PD Modification Application: MM 26-0062**Zoning Hearing Master Date:**

The applicant is seeking to modify a 9.48 acre portion of an existing Planned Development, PD 77-0123 as most recently modified by PRS 25-1203. The applicant is requesting a modification to PD Pocket 62B to allow for the development of 237 multi-family dwellings through an exchange of commercial or office use entitlements. This application is being heard concurrently with a modification to the Apollo Beach DRI (#49) under application DRI DO 26-0245.

AGENCY REVIEW COMMENT SHEET

PETITION NO: MM 26-0062

2.5 Proposed Site Plan (partial provided below for size and orientation purposes. See Section 8.2 for full site plan)

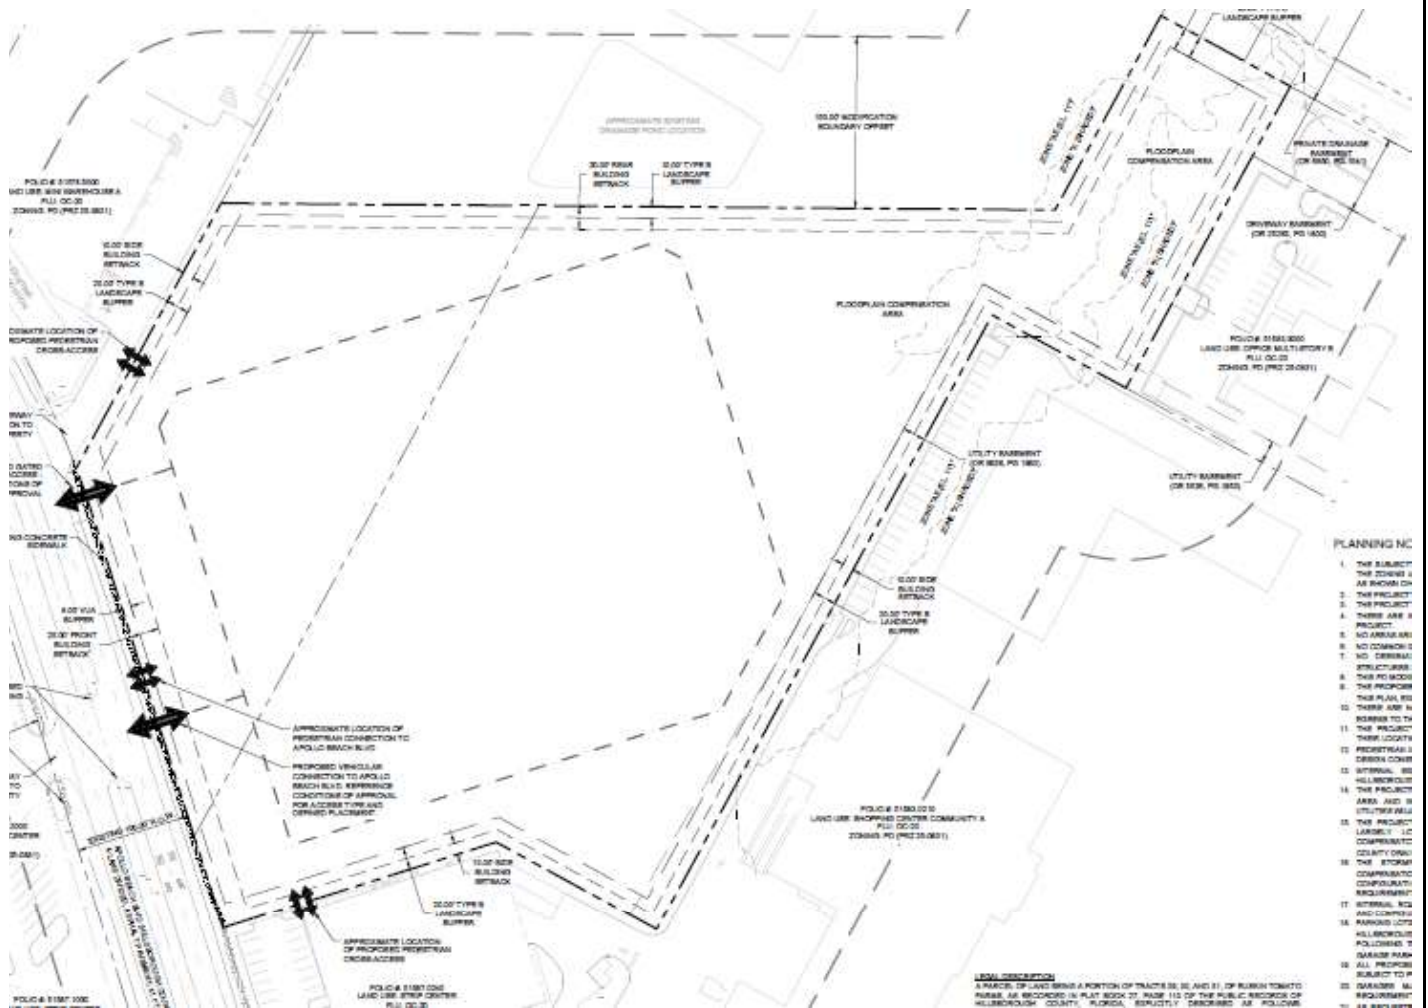
The proposed number of residential units is being provided through a conversion of commercial entitlements to residential entitlements. The conversion rate is as provided in the related Apollo Beach DRI (#49) development order. As outlined in the Additional Information (Section 7.0) and the Transportation Report (Section 9) sections of this report the amount of commercial entitlements proposed to be converted (34,511 square feet) is insufficient to achieve the requested number of residential units (237).

Based on the above considerations, staff finds the request not supportable.

Map H (Revised) May 2026
Apollo Beach, FL 33570 | Hillsborough County
Map H (Revised) May 2026
Apollo Beach, FL 33570 | Hillsborough County

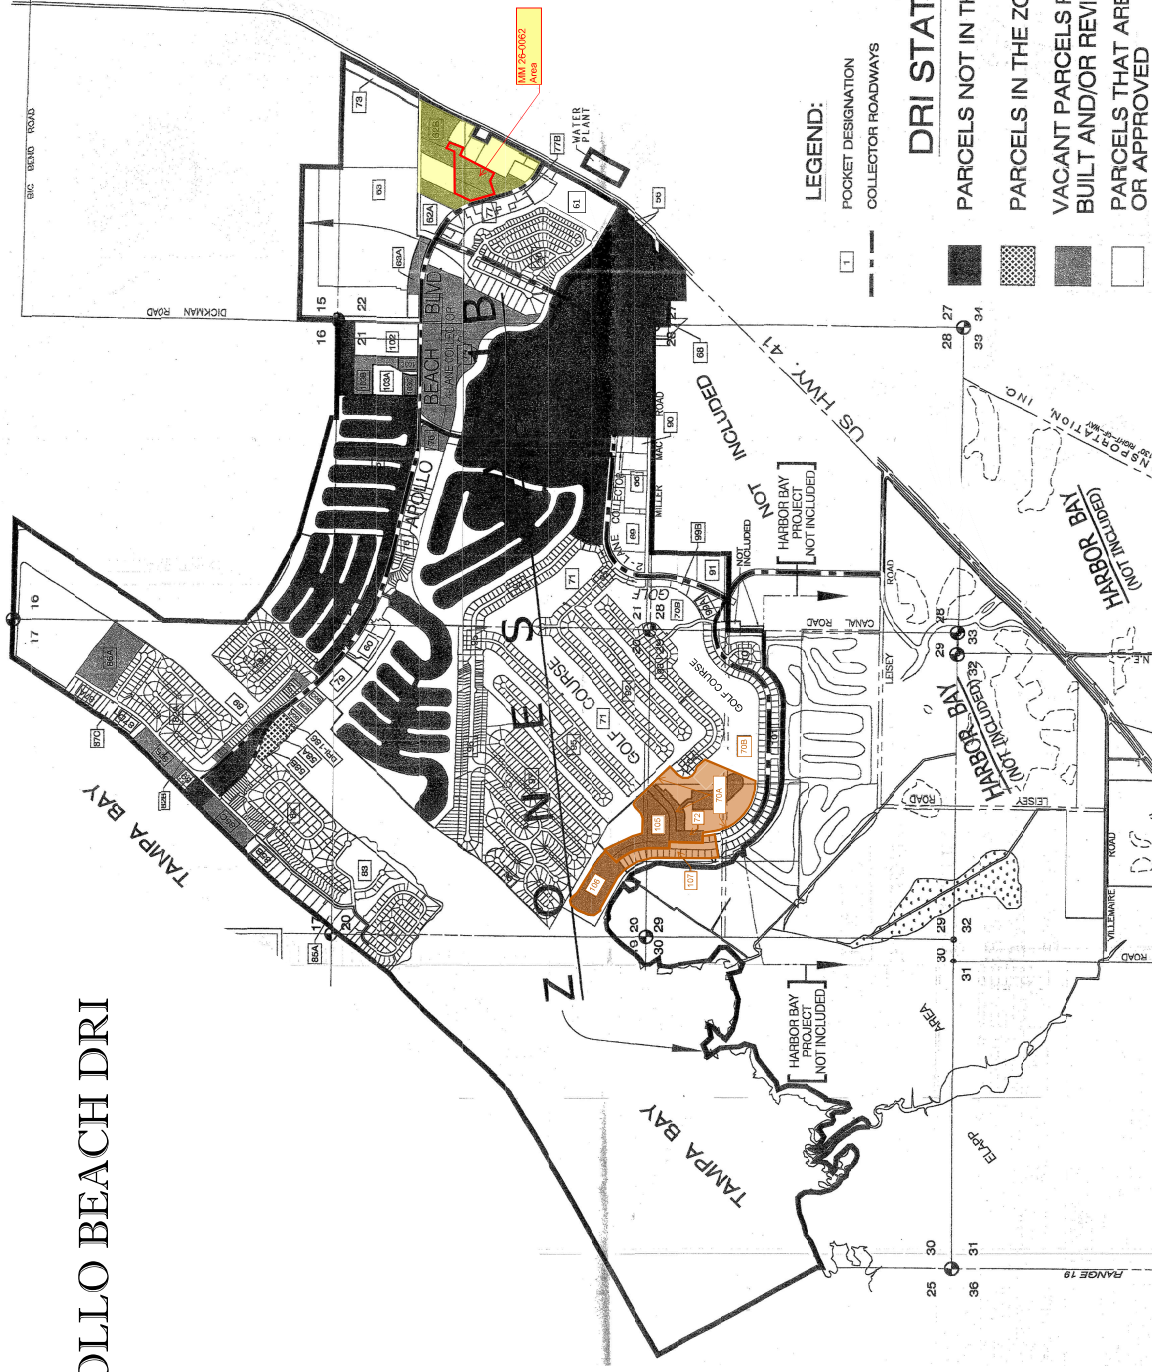
Notwithstanding the use and intensity compatibility findings, site development is required to comply with the terms and conditions contained within the Apollo Beach DRI (#49). The application does not satisfy the requirements of Section IV.A(2) of the Apollo Beach DRI (#49) as stated below, which is required for the conversion of development rights.

The summary table below shows the number of entitlements allowed in the PD and corresponding DRI, the required entitlements to qualify for the exchange and the shortage of entitlements based on the transportation related exchange ratio.
